Ex parte GIACOMO STEFANO ROBA,
MASSIMO NUTINI, and
FRANCO VERONELLI

Appeal 2009-014244¹
Application 09/986,622
Technology Center 1700

DECISION ON APPEAL

FIG. 4

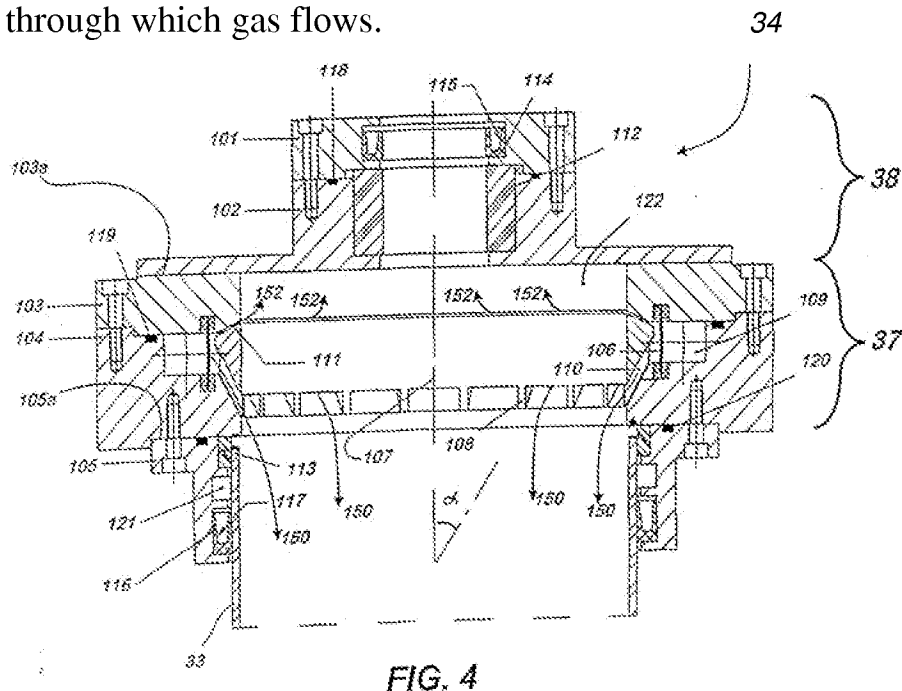
2. Appellants’ Figure 4 shows space formed between the upper surface 111 of the distribution ring 107 and the distributor casing top 103 through which gas flows.

The Examiner finds that it is unclear whether “angled path” is delimited by structure (Ans. 5). The Examiner finds that the Specification describes the upward-angled annular path 152 as being both a “path” and a “flow”, which are generally different things (Ans. 5). The Examiner contends that one of ordinary skill in the art would be confused because the paths 152 seem to be a flow of gas, which is not structure, and upper surface 111 of distribution ring 107 and casing top 103 only partially define the upwardly angled path (Ans. 6).

Appellants argue that the Specification describes the “upwardly angled path” is defined by structure (e.g., reference numerals 107, 113, and 111 in Figure 4) (App. Br. 10-11). Appellants argue that the Specification describes that “gas can flow through the upward-angled annular path 152” which indicates that the path is defined by structure and that “upward-angled path” does not refer simply to a flow of gas (App. Br. 11). We agree.

The Specification plainly discloses that an upward-angled path 152 is formed between the upper surface 111 of distribution ring 107 and a surface of the casing top 103. Though the Specification may improperly use reference numeral 152 to depict the gas flow exiting the upward-angled paths and the upward-angled paths as depicted in Figure 4, one of ordinary skill in the art would understand from the Specification that the upward-angled path as recited in claim 61 refers to structure and not gas flow.

For these reasons, we reverse the Examiner’s § 112, second paragraph, rejection of claims 61-69.
